RE: Response to Comments, Bennoc Area NPDES OIL00159 Application for American Energy Corporation in Belmont County, Ohio

Response to OEPA Comments from Bruce Goff and Eric Nygaard Dated 8/21/12, 8/15/12, 7/20/12, 7/13/12, and 7/11/12 Bennoc NPDES Permit Application OIL00159

Hydro-Chemical Analysis of Waste Water Discharge and Anti-Degradation Assessment: American Energy Corporation's Bennoc Coarse Coal Refuse Area Ponds 001 and 002

Wheel treatment system – pictures provided by www.chemstream.com

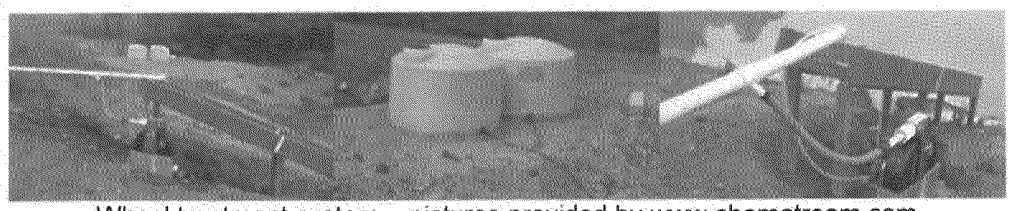
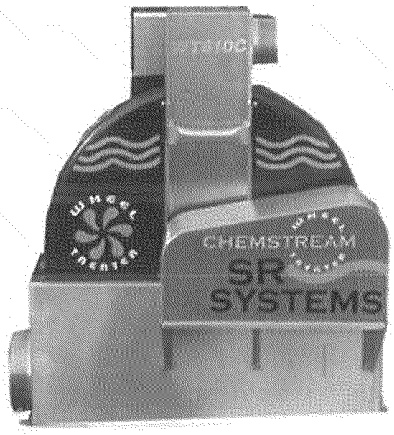
Comment: Do you happen to have any photos of the treatment ponds, the outlet structures, the chemical feed equipment and the discharge drainage ways (outlet ditches) you can share?

Response: We do not have any pictures of the proposed treatment ponds and their structures. However, we do have a picture (below) of the proposed wheel treatment system.
